CORSO CHEVY CHASE

LOCAL MAP AMENDMENT H148

FLOATING ZONE PLAN

Thank you for the opportunity to comment on the second resubmission of Local Map Application H-148 filed by Corso Chevy Chase on January 13, 2023. The Town has carefully reviewed this resubmission.

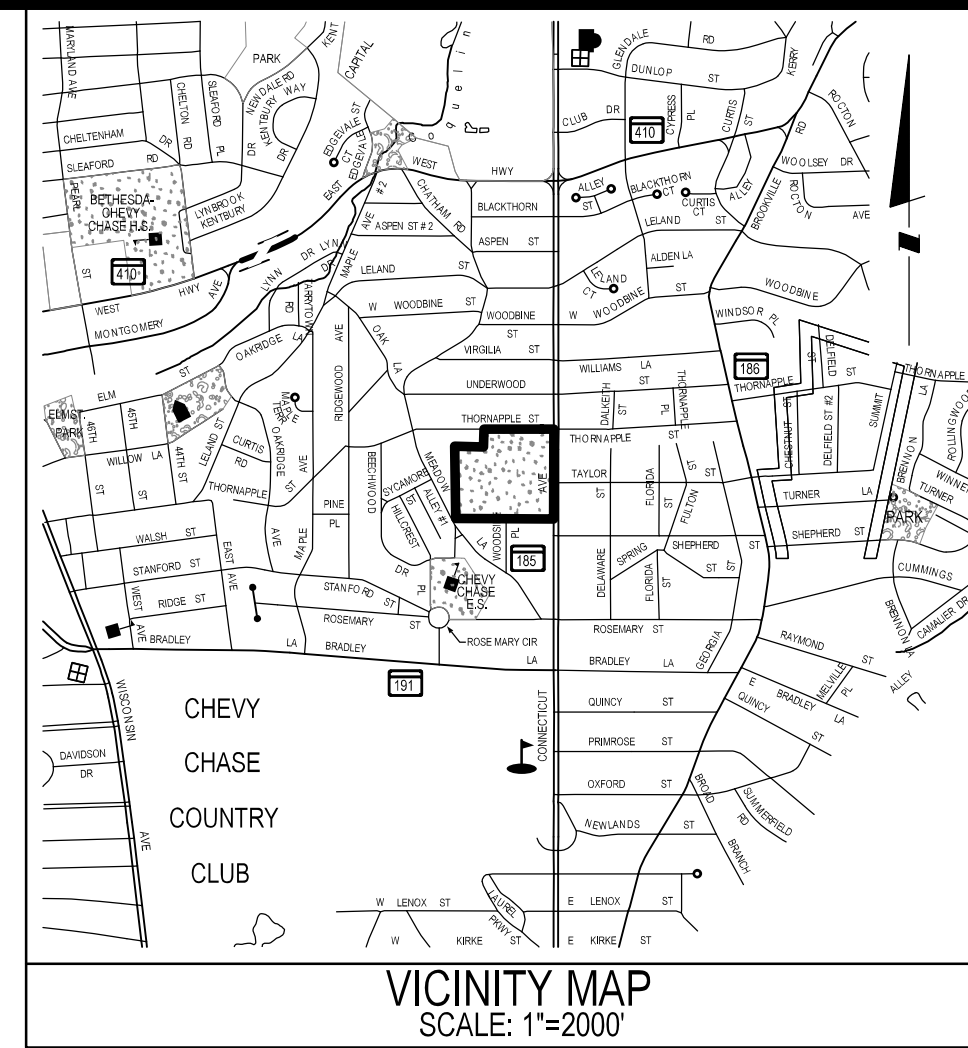
- We see no evidence that taller buildings are in the center of the project, as Corso has previously stated was reflected in their design and which we supported. Indeed, the resubmission continues to show that the two buildings nearest the center are only 35' and 45' feet high --offering ample room to shift density towards the middle of the project.

In its resubmission, Corso rejects our modest request for an adjustment to the public pathways. The Town supports paths from the project to both Woodside Place and Thornapple Street. What we asked for was the elimination of the short pathway that would run directly from the southeast corner of building C1 to Connecticut Avenue. The stretch of path that runs along the east side of building C1 to the main entrance would remain in the plan. We want to facilitate connection among all Town residents, both those in single-family homes and in Corso, but we do not want to create a new public walkway that would lead directly from Connecticut Avenue to Woodside Place.

It appears in the latest drawings that all the storm water runoff will be collected and directed through a single pipe to Meadow Lane and that no stormwater will flow through a second existing pipe to Thornapple Street. While we do not have a view at this time as to whether this is an optimal dispersion of stormwater, we emphasize the importance of the Binding Element that sets out the requirement for the Town to be involved in reviewing the storm water management plans. We will be focused on determining a plan that will minimize any stress on the stormwater

The developers propose to hold the height along Connecticut Avenue to 60 feet but continue to plan for 70-foot buildings around the rest of the perimeter, from the measuring point identified in the application. This translates to 5 stories generally and 6 stories, effectively, for the building on the northwest corner of the site. Meanwhile, in the Statement of Case, Land Use Report, the developers state *"The design of this Project is residential in nature and includes several buildings with heights ranging from four- to five-stories, with the taller heights oriented toward the center of the Property and lower heights adjacent to the perimeter of the site."* [emphasis added.] We are in support of this concept, as a means to adjust the density of the project; but we have not seen plans that demonstrate implementation of this concept.

The Applicant shall maintain minimum building setbacks as shown on the Floating Zone Plan, including a maximum building height of sixty (60') for a distance of eighty feet (80') from Connecticut Avenue.

PRELIMINARY FOREST CONSERVATION PLAN

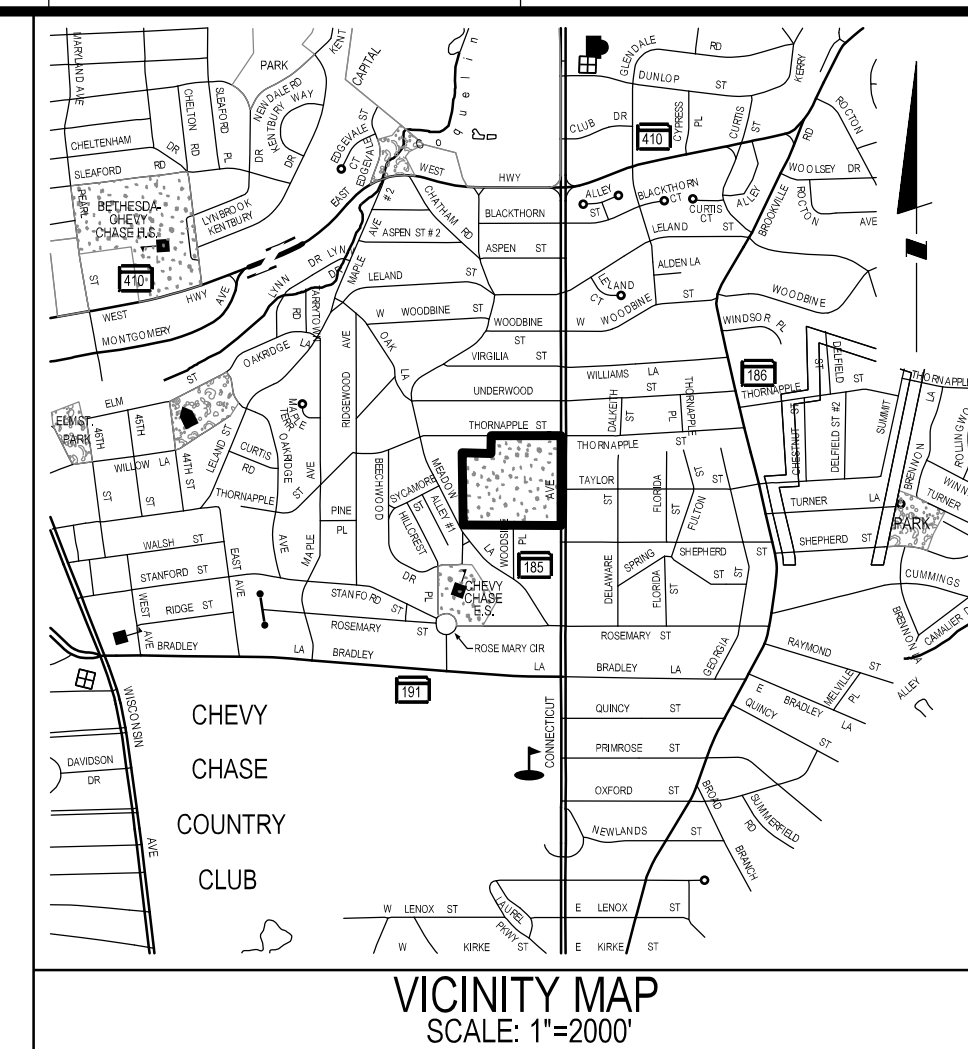
Please see the below analysis and recommendations for the preservation of two street trees at the Corso Chevy Chase project site, located at 7100 Connecticut Avenue in Chevy Chase, Montgomery County Maryland. The trees are identified as Trees 50 and 51 on the Preliminary Forest Conservation Plan.

These trees are well worth preservation, though success will require careful attention to detail during the demolition and construction phases and will likely require modifications to the design. Each of these is addressed below.

- Typical sections for asphalt trails show an additional 6-inch width to the base course projecting beyond the edge of the paving. This would need to be modified to use the existing base course, as there is no room east of the existing sidewalk to expand towards the tree.

- Curb removal work near Tree 50 shall occur from the Connecticut Ave side, carefully pulling curbing away from the planting strip.
- Debris, materials, and tools must be stored outside of CRZs.

- Replace curb and gutter in place, working from the street side. Arborist to excavate for curb forms with airtool. Roots to be pulled back with burlap and temporarily pinned in place while curb is poured/cured. Backfill behind new curb by hand. All masonry materials and washout areas must be located outside of CRZs.
- Roots less than 2 inches in diameter may be hand pruned by Arborist at Arborist's discretion. Roots encountered above 2 inches in diameter shall be reviewed by the Arborist, Contractor, and M-NCPPC inspector.
